Origination Form
Proposed Revisions to a Standard Plans Index

Originator:	Meyer, Ronald and Lemus, Vivian	Index Number:	700-120
Date:	6/22/2026	Sheet Number(s):	1,2,5,6,7
E-mail:	Ronald.Meyer@dot.state.fl.us	Index Title:	ENHANCED HIGHWAY SIGNING ASSEMBLIES

ROADSIDE SIGN ASSEMBLY-5

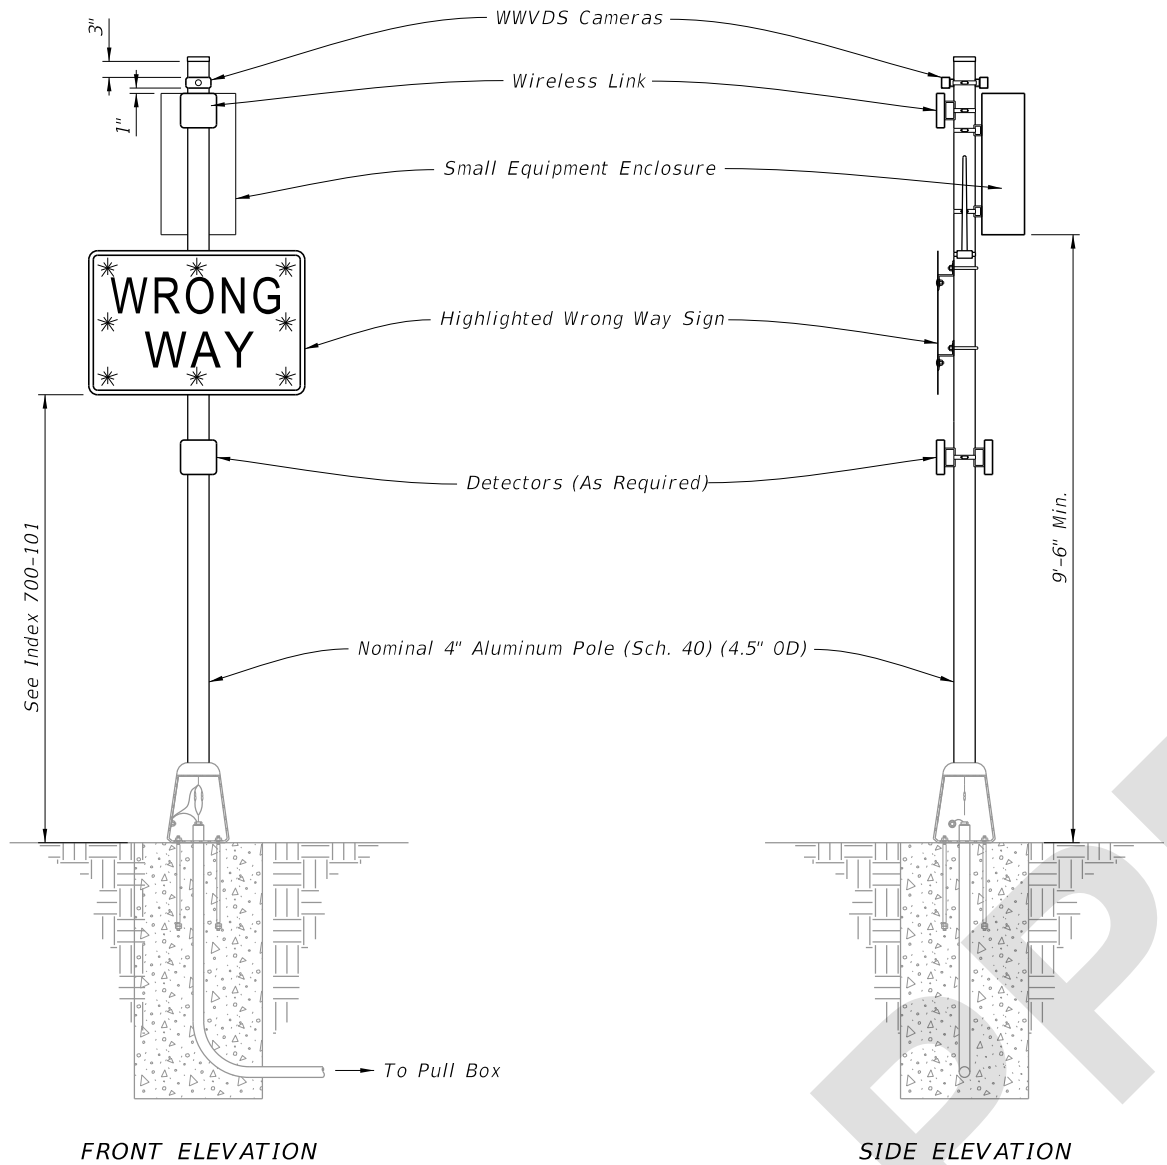
Sheet 7 (New Sheet 6): Added "(Per Plans) to the 12" Yellow Flashing Beacon callout; Deleted dimensions for R2-1; Updated the "Electronic Speed Feedback Sign" to "W13-20aP Vehicle Speed Feedback Plaque; Updated the "Your Speed" sign to match the shape and size of the W13-20aP Vehicle Speed Feedback plaque as required and shown in the latest MUTCD; Deleted Note 2
